TDECQ and SECQ vs Rx sensitivity:
review of previous presentations
and proposed changes
(comments i-58, i-82, i-83, i-84, i-79, i-80 i-81)

IEEE Interim, P802.3cd, Geneva, January 2018
Jonathan King, Finisar

Analysis of way_3bs_01a_0517

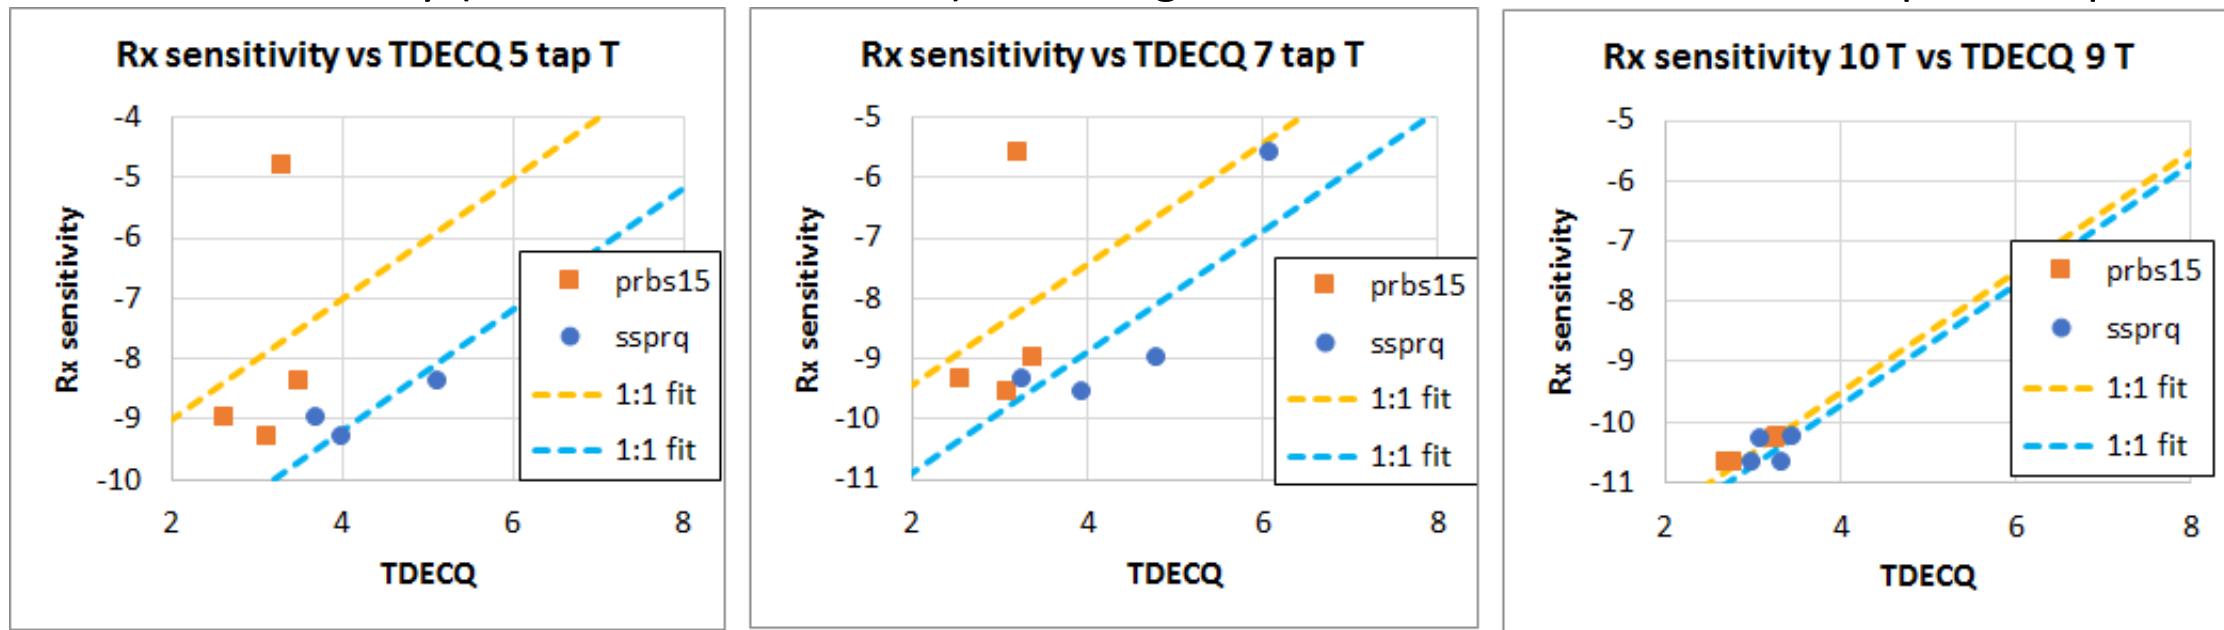
- The data shows a reasonable match to a 1 dB per dB relationship for TDECQ and RX sensitivity – the RMS error is consistent with correlation of two practical measurements
 - Difference in TDECQ values for 5 T-spaced taps correlates with difference in receiver sensitivity – similarly for 7 or 9 taps

Analysis of chang_cd_01_1117: BER plots vs SECQ (5 tap T-spaced)

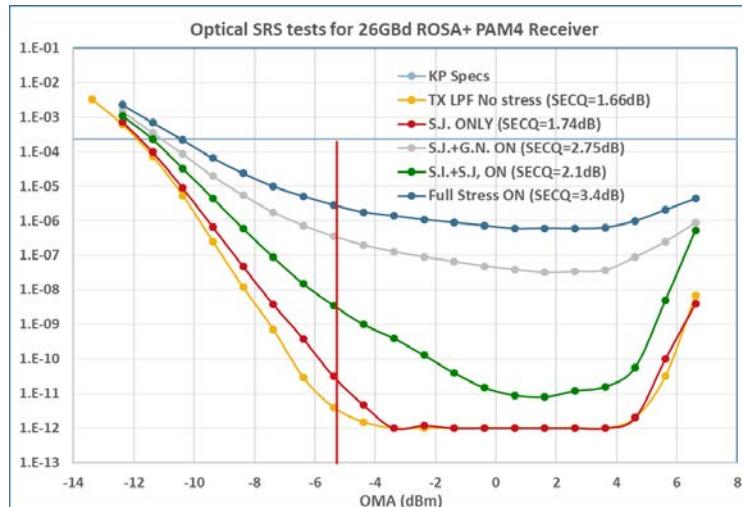
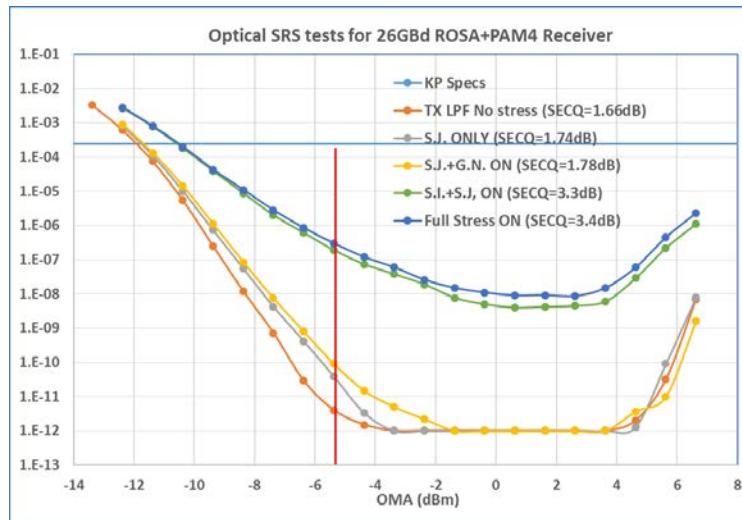
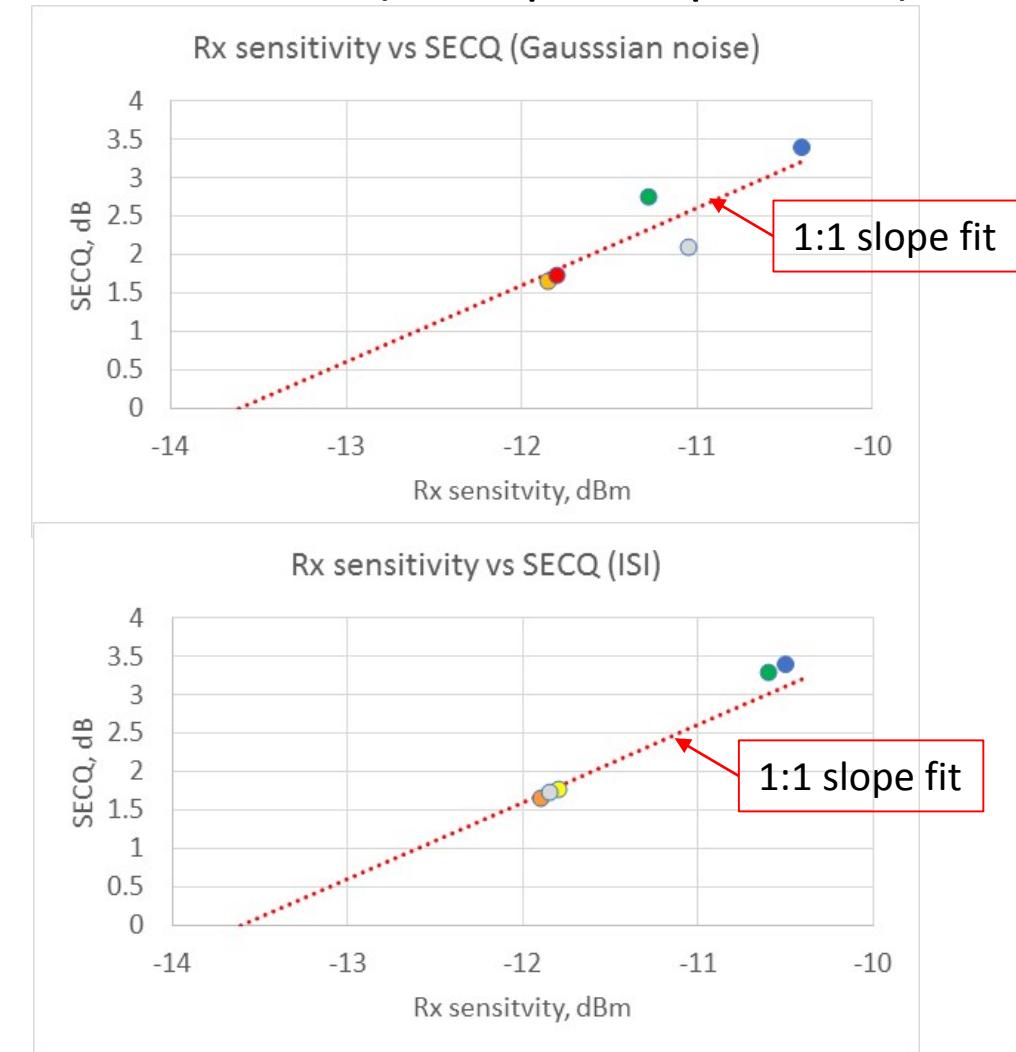
Very good dB/dB fit for both cases

- [chang_3cd_01_1117](#) concluded that “There exists strong interplay between G.N and S.I (with S.J.). G.N. impact most the BER degradation in SRS.”. But the data shows very good correlation between SECQ and Rx sensitivity for both GN and SI dominant stress (RMS error of <0.3 dB)

Analysis of baveja_3cd_01_1117, slide 1

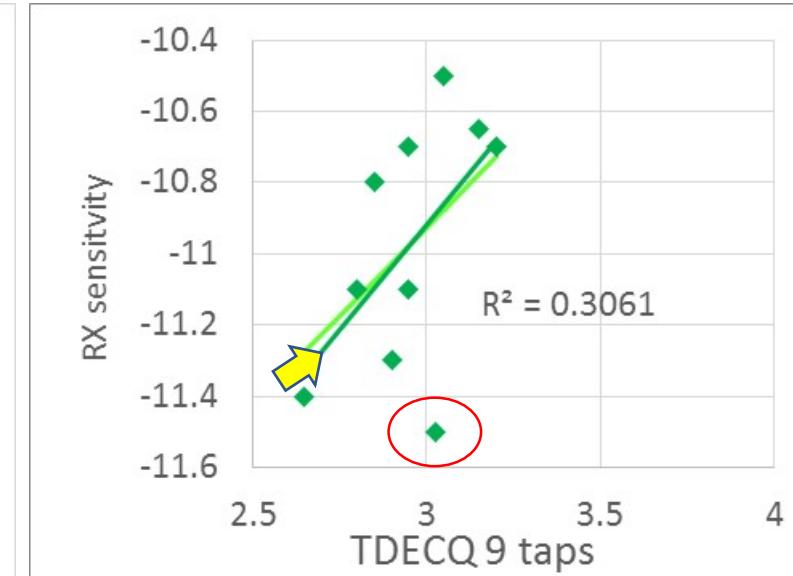
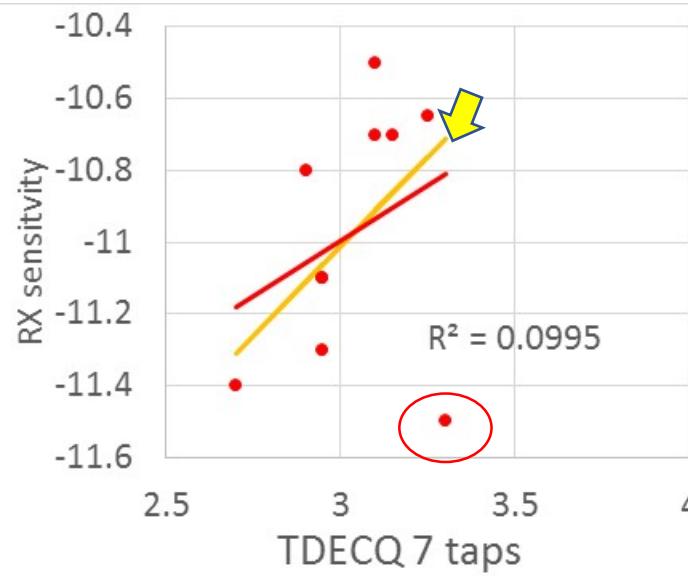
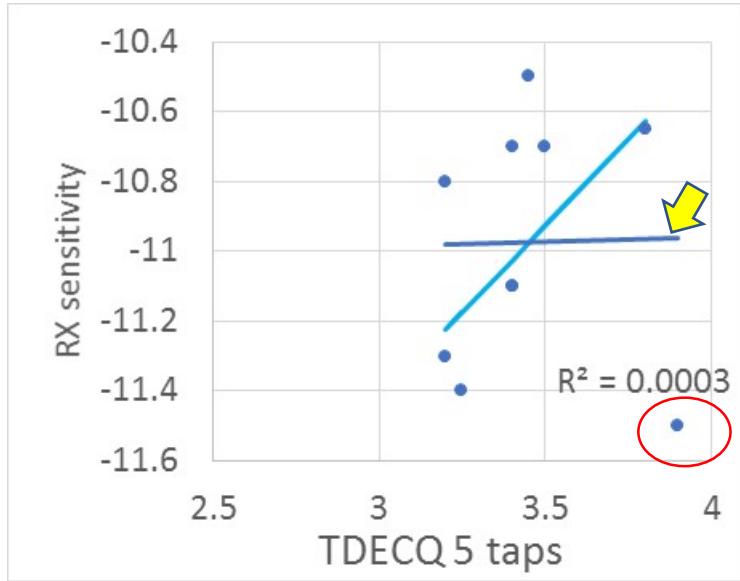
A linear fit to a limited data range is not a good way to evaluate the dB/dB correlation of RX sensitivity and TDECQ

Note: One measurement out of the 10 shows 2x larger shift in TDECQ as number of taps increase – a warning flag

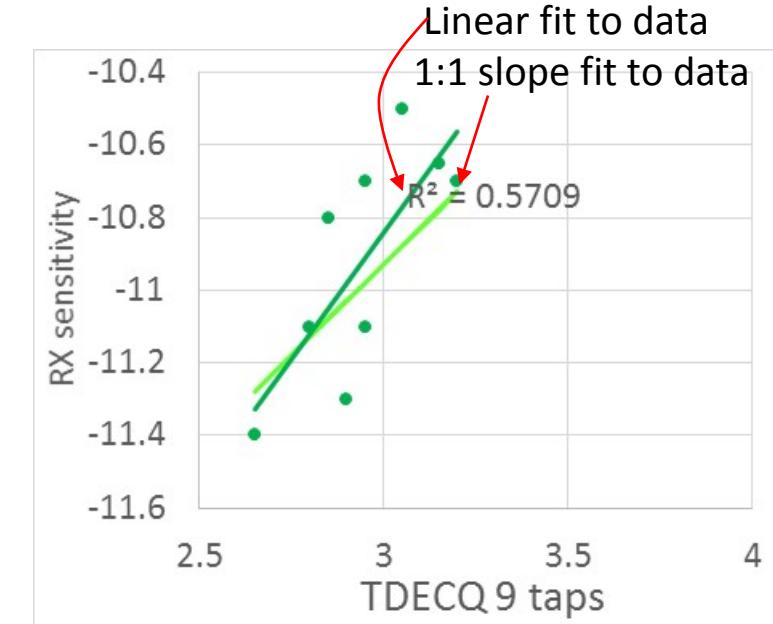
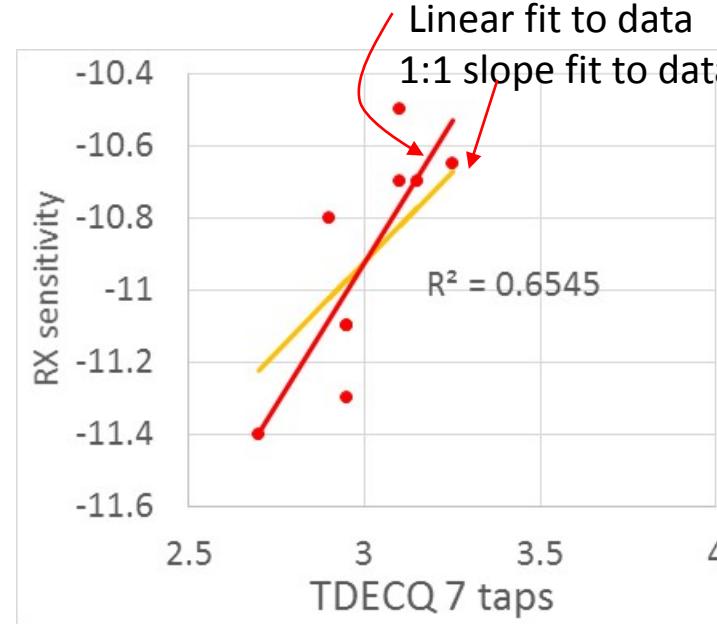
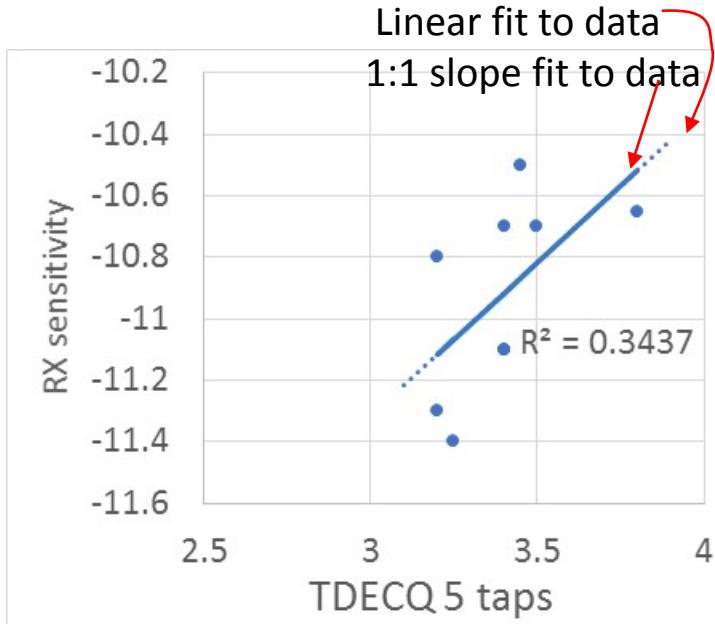
Probably because the RX used for this data has >>9 taps, and the outlier TX has significant ISI extending to 9 UI

This one data point dramatically affects the rest of the data

Q penalty vs R_{LM}

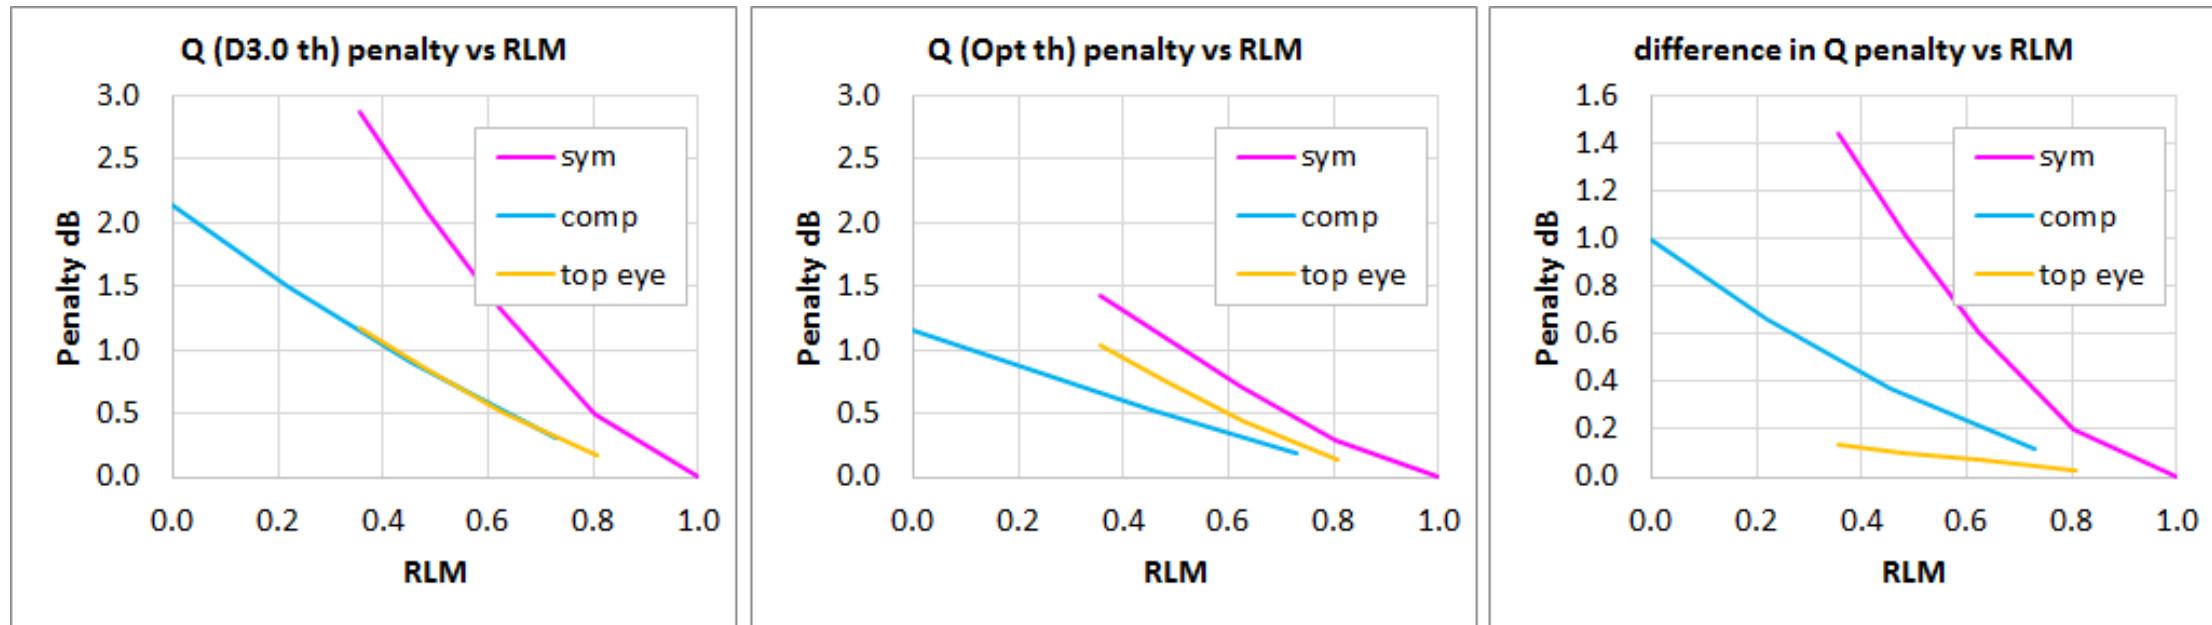
- Symmetric eye inequality produces higher penalty than other forms of eye distortion
- R_{LM} is a poor predictor of Q penalty

Q penalty vs threshold difference (D3.0 vs optimum)

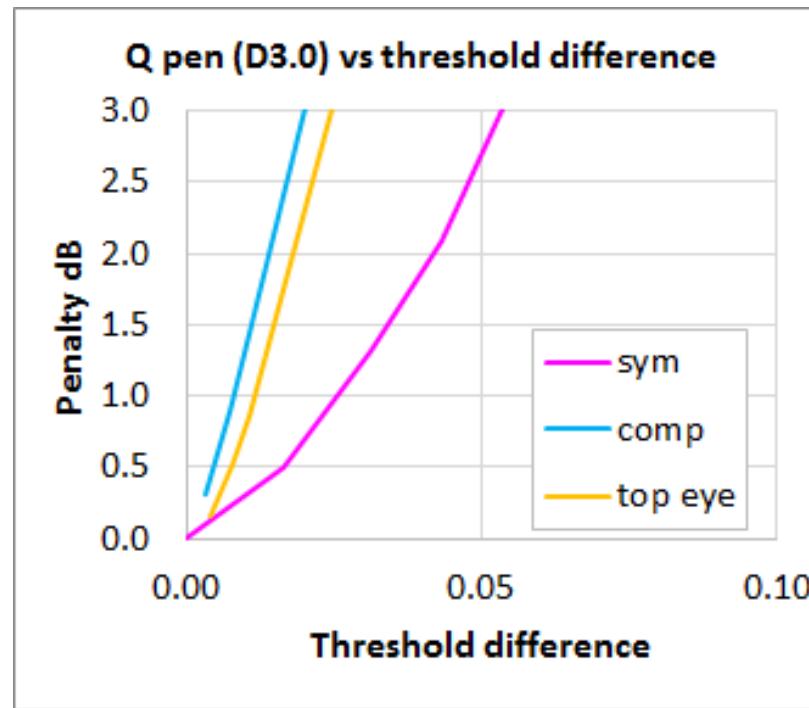
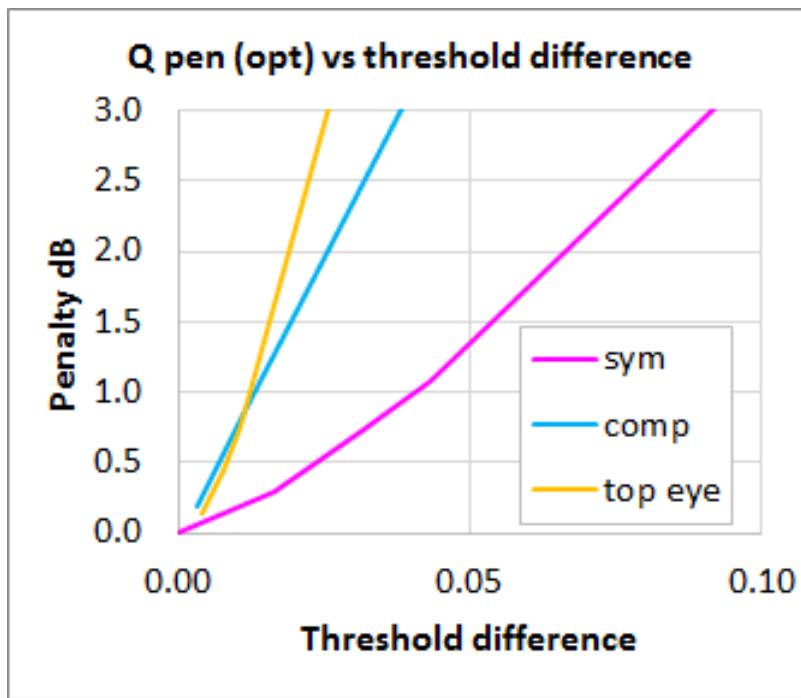
- Threshold difference is a bad predictor of Q penalty
 - Avoid using it as a spec limit

Q penalty (optimum) vs Q penalty (D3.0)

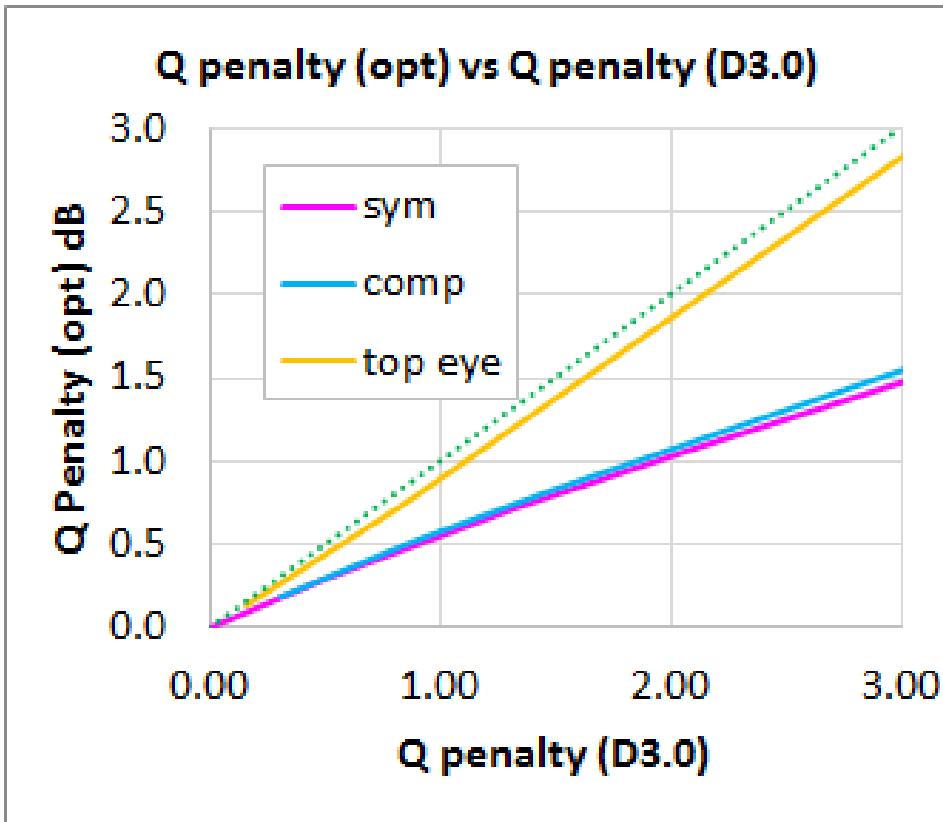
- Q penalty (D3.0) is a reasonable predictor of worst case penalty for a receiver with optimized thresholds
 - Q penalty (D3.0) is a proxy for the D3.0 definition of TDECQ
